ADDENDUM NO. 3 JUNE 6, 2022 PAGE 1

- SD-004, Storefront Elevations
- RFI Responses:
 - o Balton; RFI 28-30
 - Stuebner: RFI 02Dolan RFI 01
 - Uhrig RFI 01
 - o HB Frazer RFI 01

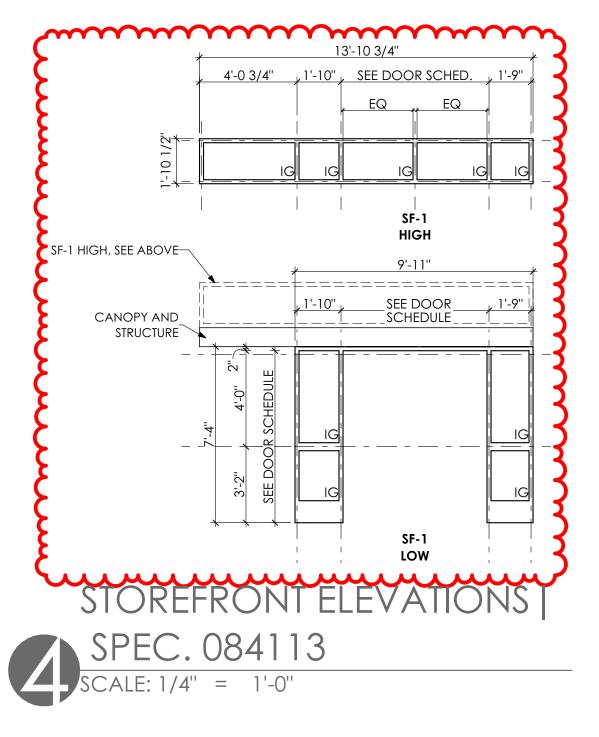
- 1. **MODIFY** key note 22.01.05 to read: ROOF DRAIN, BY G.C. RAINWATER CONDUCTOR PIPING BY P.C. P.C. TO PROVIDE FINAL CONNECTIONS TO ROOF DRAIN.
- 2. **MODIFY** drawing 4/A-601 Storefront SF-1 elevation. See attached drawing SD-004, Storefront Elevations, dated June 6, 2022.

The transom lites height will be reduced as shown in the wall sections. We will be issuing a revised elevation for the storefront.
